NAVIGATION - STALL WARNING HORN REPLACEMENT

DESCRIPTION

SEB-34-22
Page 1 of 10

Figure 1. Warning Horn Modification (Sheet 1)

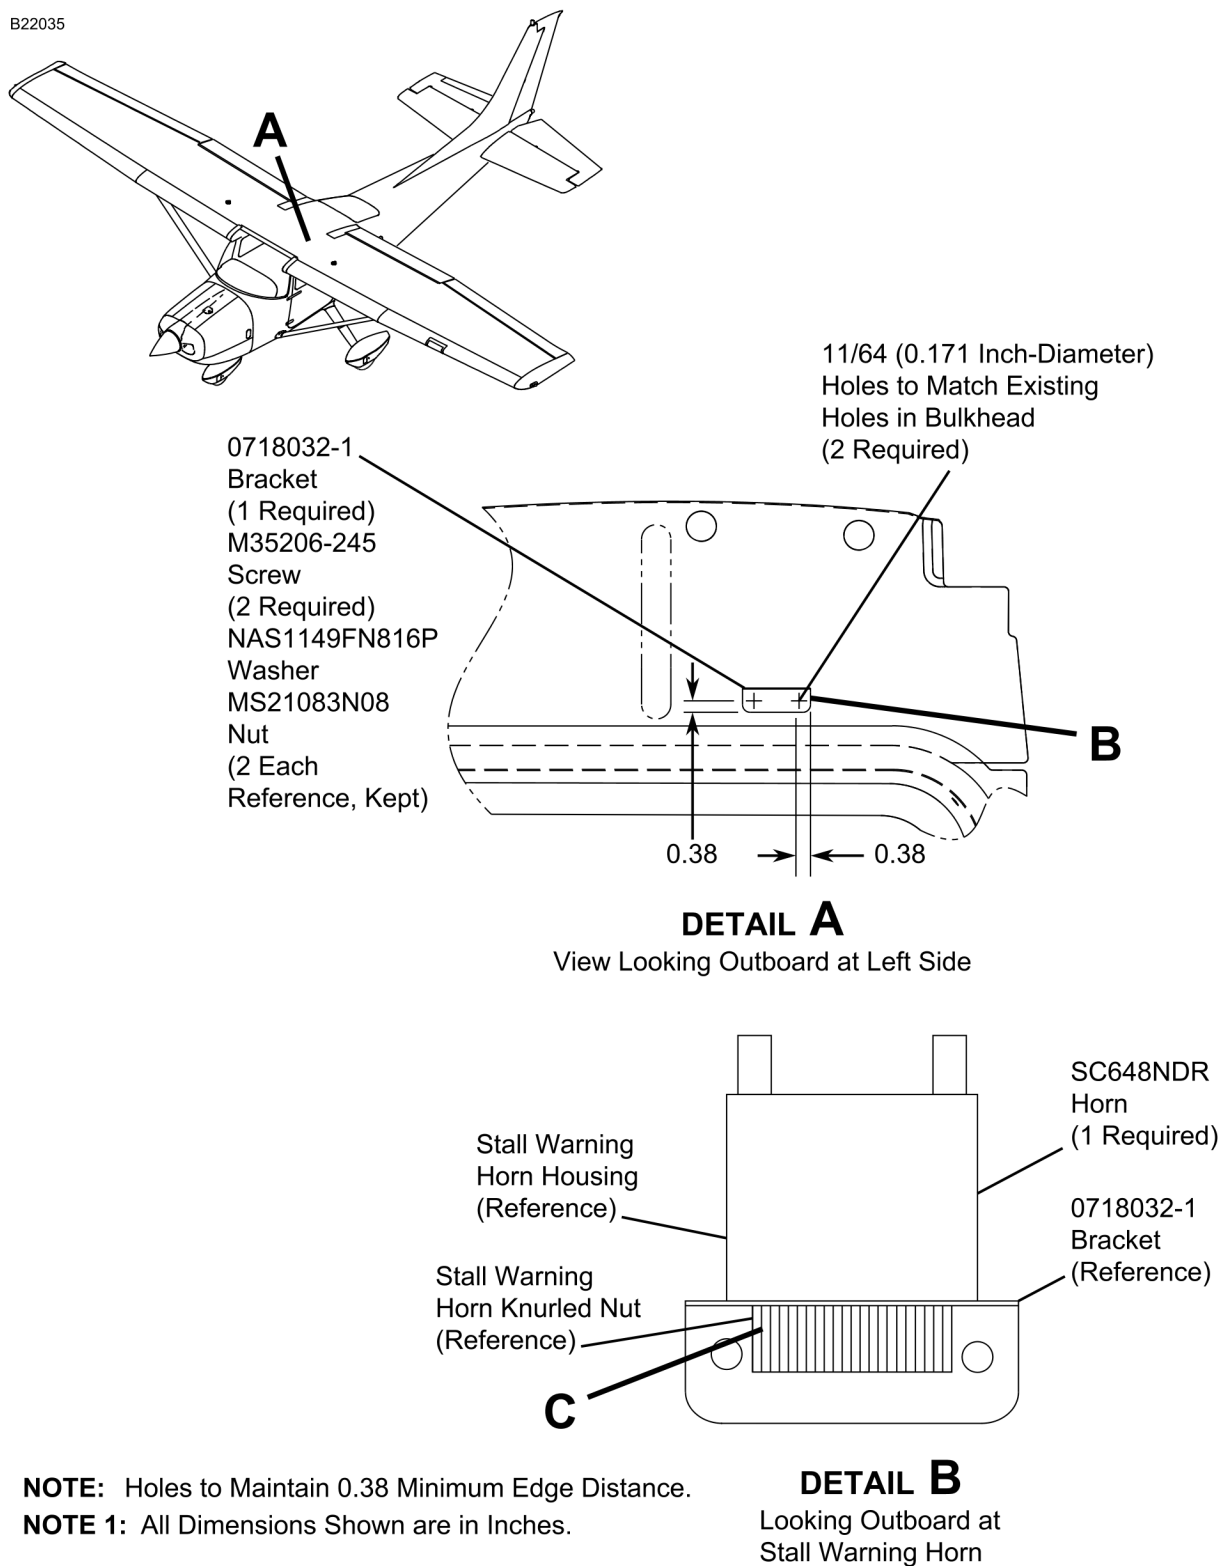
NOTE: Only the lower straight wing root fairing will need to be removed. The wrap around and top fairing will not need to be removed.
3. Remove headliner to access stall warning horn assembly. (Refer to Chapter 25, Interior Upholstery - Maintenance Practices.)
4. (Refer to Figure 2, Sheet 1.) Disconnect wiring connector P1 from JC030.
5. (Refer to Figure 1, Sheets 1 and 2.) Remove two MS21083N08 Nuts and NAS1149FN816P Washers that attach the stall warning horn assembly to the bulkhead. Keep the nuts and washers.
6. (Refer to Figure 2, Sheet 2.) Remove the stall warning horn from airplane.
7. (Refer to Figure 1, Sheets 1 and 2.) Install the 0718032-1 Bracket as follows:

- A. Position and center the 0718032-1 Bracket over the two holes in the bulkhead where the stall warning horn was removed.

- B. Match drill two 11/64 (0.171-Inch Diameter) holes in the 0718032-1 Bracket.

- D. Install the 0718032-1 Bracket with two M35206-245 Screws, the kept washers and nuts.

Figure 1. Warning Horn Modification (Sheet 2)

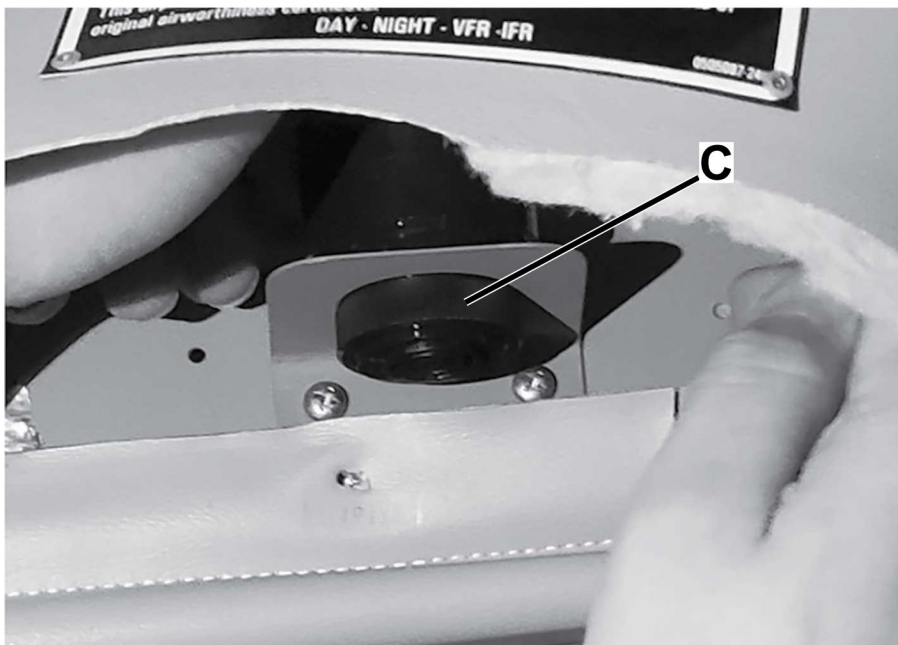
8. (Refer to Figure 1, Sheets 1 thru 3.) Install the SC648NDR Horn as follows:

Before Modification, Old Horn

After Modification, New Horn

- B. Put the SC648NDR Horn into the 0718032-1 Bracket.

Figure 1. Warning Horn Modification (Sheet 3)

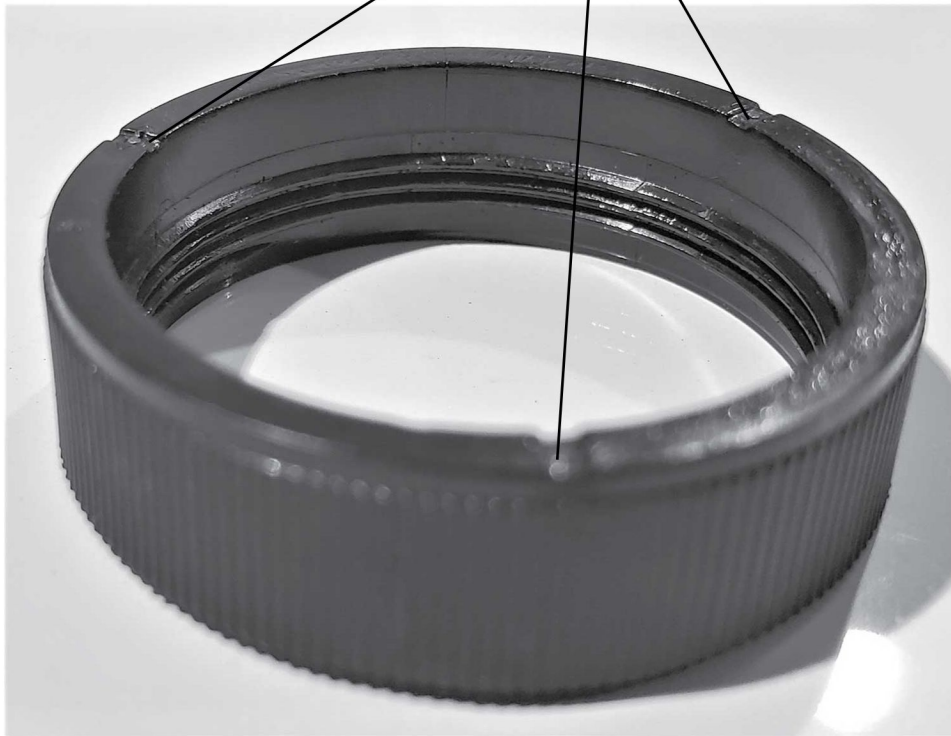
NOTE: (Refer to Figure 1, Sheet 3.) The plastic knurled nut must be installed with the three indents toward the bracket and horn assembly. On the internal circumference, the smooth side without threads is installed first, towards the bracket and horn. This technique of installation will make sure the nut fully seats against the bracket and not bottom-out on the threads. If not installed correctly the knurled nut will bottom-out on the threads and the horn assembly will not be fully tightened in the bracket.

Install with three detents first.
Detents go toward bracket and horn.

Figure 2. Wiring Modifications (Sheet 1)

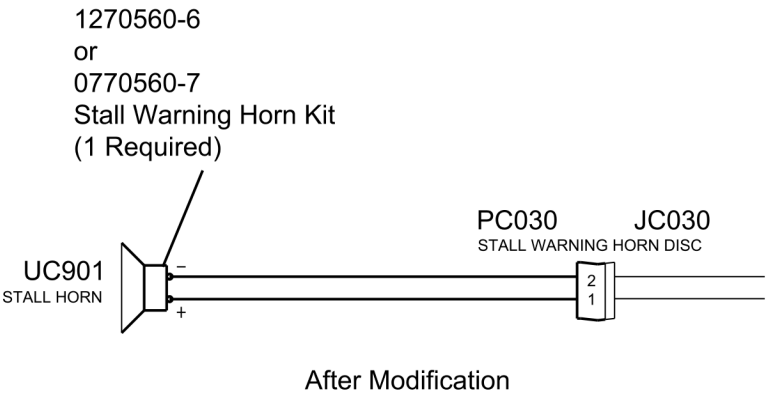
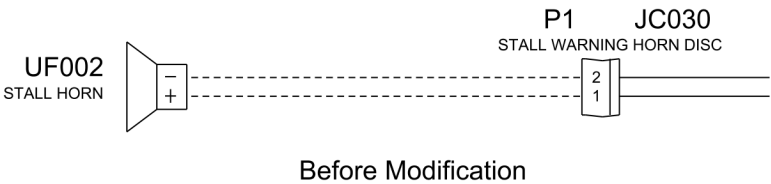
9. (Refer to Figure 2, Sheet 1.) Connect wiring connector PC030 to JC030.

Figure 2. Wiring Modifications (Sheet 2)

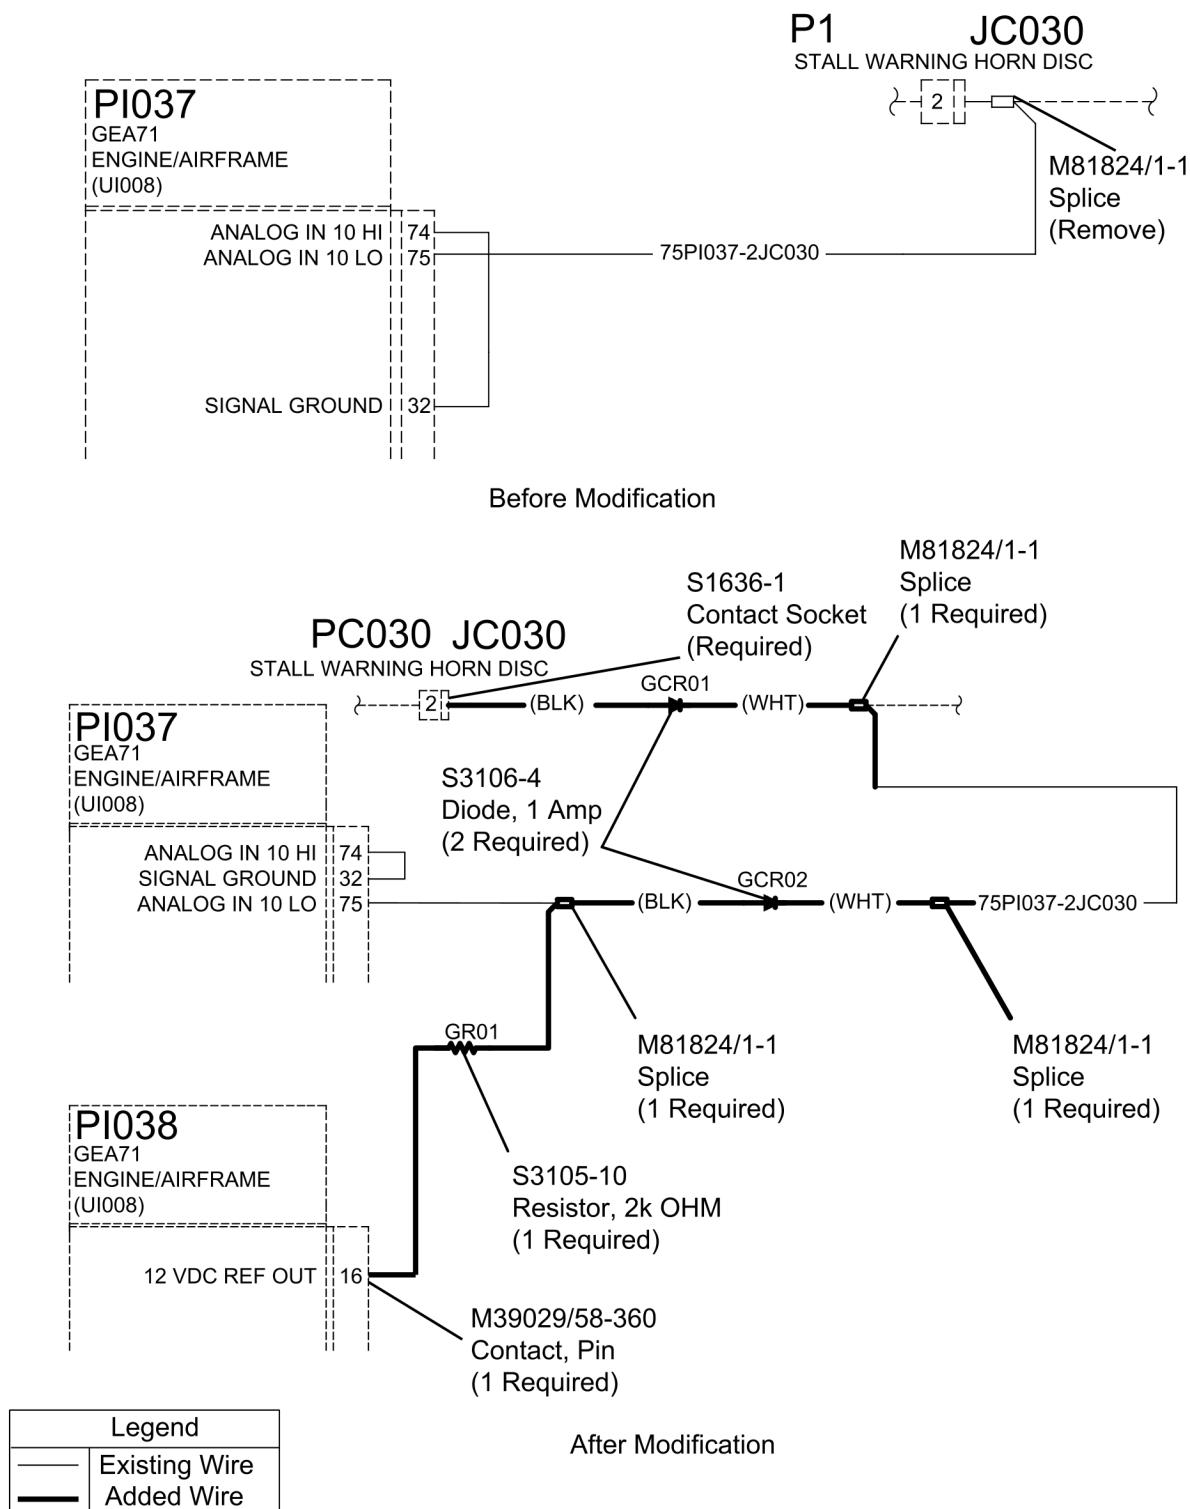
10. (Refer to Figure 2, Sheet 2.) Airplanes listed, do the wiring modification as follows:

- A. Install two S3106-4 2 Diode Assemblies and one S3105-10 Resistor Assembly with M81824/1-1 Splices, S1636-1 Contact Socket, and M39029/58-360 Contact Pin. (Refer to the applicable Model Wiring Diagram Manual, Chapter 20, Splices and Terminals - Maintenance Practices.)

NOTE: The diode and resistor assemblies have sufficient leads to allow butt-splice into the aircraft wiring. Use best shop practices for access, assembly, protection with heat shrinkable tubing, and wire-tie to secure wire bundles after the modification.
